**Submission in regards to DA/2022/0670 Development Application  
18 Margaret Street, Fairlight**

*“Alterations and additions to a dwelling house.”*

**Figure 4 – Proposed western elevation with new works in colour (Complete Trade, 2022)**

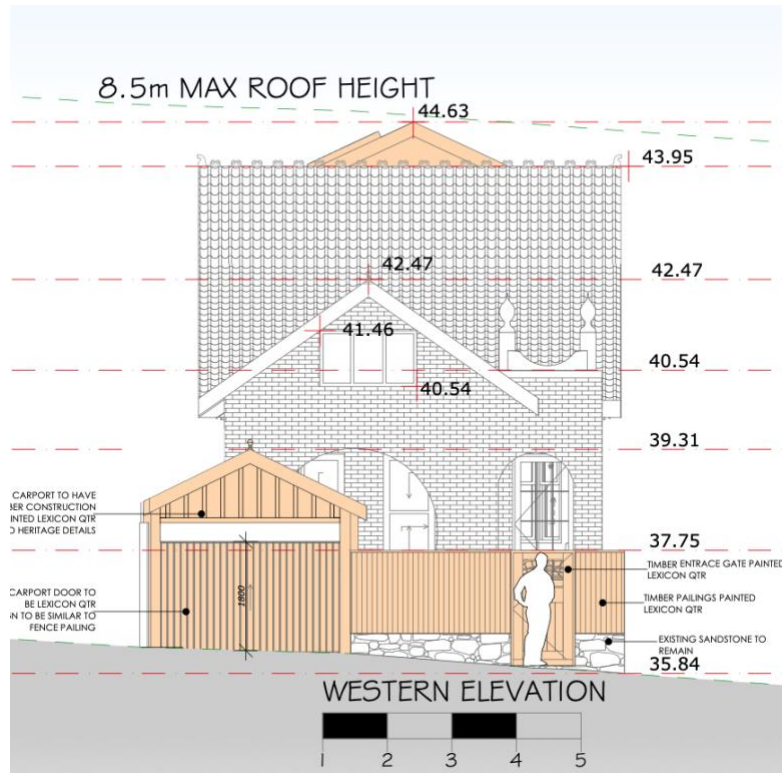
The changes under DA/2022/0670, however, are highly visible from the street and disrupt the special aesthetic unity that 16 and 18, and other sites along Margaret Street share. Figure 4 highlights the way in which the proposed raised pitched roof will sit well above the ridge of the original front roof, altering the established roof pattern. Figure 5 shows the high visibility of 18 Margaret Street when viewed from the side, which any new raised roof will also dominate.

The increase in upper roof ridge height above the existing highest roof ridge is not necessary to accommodate for upgrades at 18 Margaret Street. Development at 16 Margaret Street shows the way in which contemporary changes can be skilfully concealed and their impact minimised, specifically through the location of all new first floor components at the same height or lower than the existing ridge. Implementing a similar approach at 18 Margaret Street will allow the original front roof to be celebrated, and allow new works to lie visually subservient from the public domain.

- a) **Action:** Retain the existing roof height along all portions of the building.  
**Outcome:** This will result in no additional shadow for 16 Margaret Street, and protect the heritage value of the site and wider Heritage Item.

**Figure 6** – Existing side setback between 16 and 18 Margaret Street (Corona Projects, 2022)

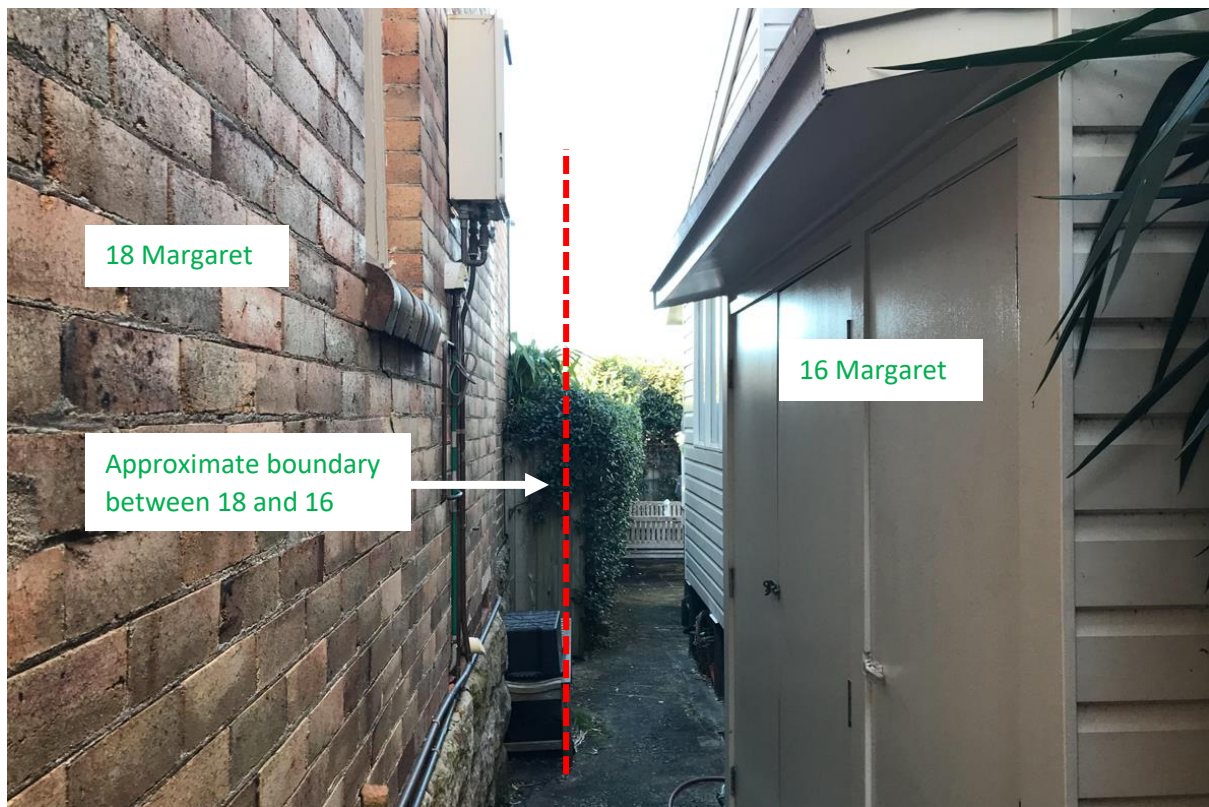
The proposed southern side boundary fencing would unnecessarily restrict access to maintain services along the southern elevation of 18 Margaret Street, creating an obstacle rather than a solution for the site. Once fenced, access to the southern elevation of 18 Margaret Street from the northern side setback of 16 Margaret Street will not be available.

Furthermore, the construction of new side boundary fencing would require the demolition of existing fencing and hedging in the eastern-most portion of the two sites which currently provides visual privacy. This hedging is seen in the distance in figure 6. Any new fencing constructed should maintain the privacy by featuring at least 1.8m heights along the entire length of the boundary.

**Outcome:** This will allow for an accurate assessment of the proposal and solar impact.
- d) **Action:** Remove the proposed southern boundary fence, or locate it entirely on the land belonging to 18 Margaret Street with a 1.8m height along the entire site length. Confirmation of the boundary line by an independent surveyor should be obtained.
